STINSON SERVICE INFORMATION LETTER NO 75

Rework of Plunger Assembly P/N 108 - 5182006

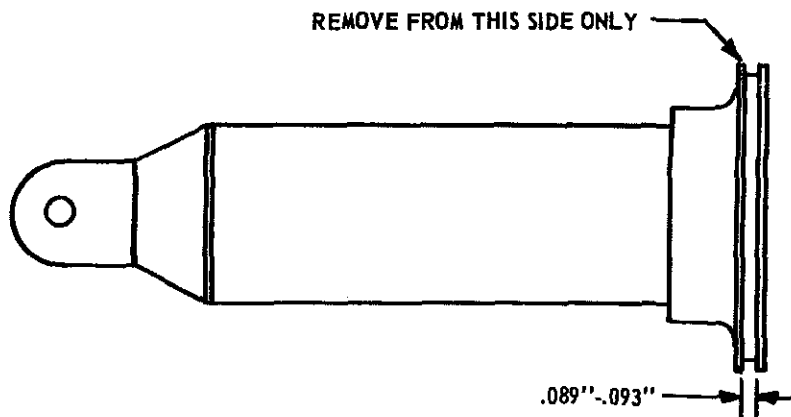
The original -12 wiper rings are no longer available. A substitution has been made which requires reworking the ring groove. This rework is required only on installation of new wiper rings.

1. Remove shock absorber from aircraft
2. Remove plunger assembly from shock absorber.
3. Remove three old rings from plunger assembly.
4. Turn ring groove width to $.089''-.093''$ per drawing to accommodate increased thickness of new rings.
5. Fit rings into shock absorber cylinder and file ends of rings as required to obtain an end clearance of $.025''-.030''$.
6. Install rings on plunger assembly. Stagger ring gaps approximately 120 degrees apart.
7. Reassemble shock absorber using new O rings.
8. Install shock absorber on aircraft and refill with petroleum base hydraulic fluid per service manual instructions.
